Accessibility Survey

City of Downey Mantee Street - Mcgovern Avenue to Gurley Avenue

Date of Inspection 8/29/2017

Disability Access Consultants

Sidewalks , Surface : Cross Slope

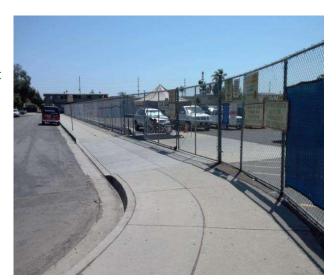
Sidewalk cross slope is not compliant.

On-Site Finding 3.60 percent for 200.00 feet

Repave the sidewalk surface with the recommended cross slope.

Recommendation Up to 2.08 percent

Sidewalks , Surface : Cross Slope

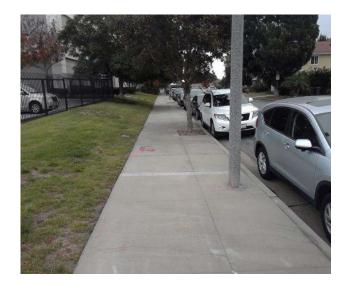
Sidewalk cross slope is not compliant.

On-Site Finding 2.80 percent for 95.00 feet

Repave the sidewalk surface with the recommended cross slope.

Recommendation Up to 2.08 percent

Sidewalks : 60X60 Turn Area

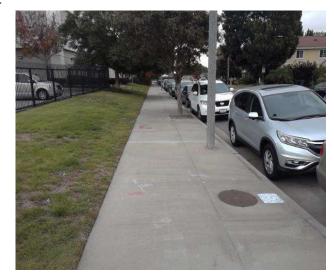
There is no 60X60 turn area at every 200 feet.

On-Site Finding Not Found

Provide a 60X60 turn every 200 feet on the sidewalk.
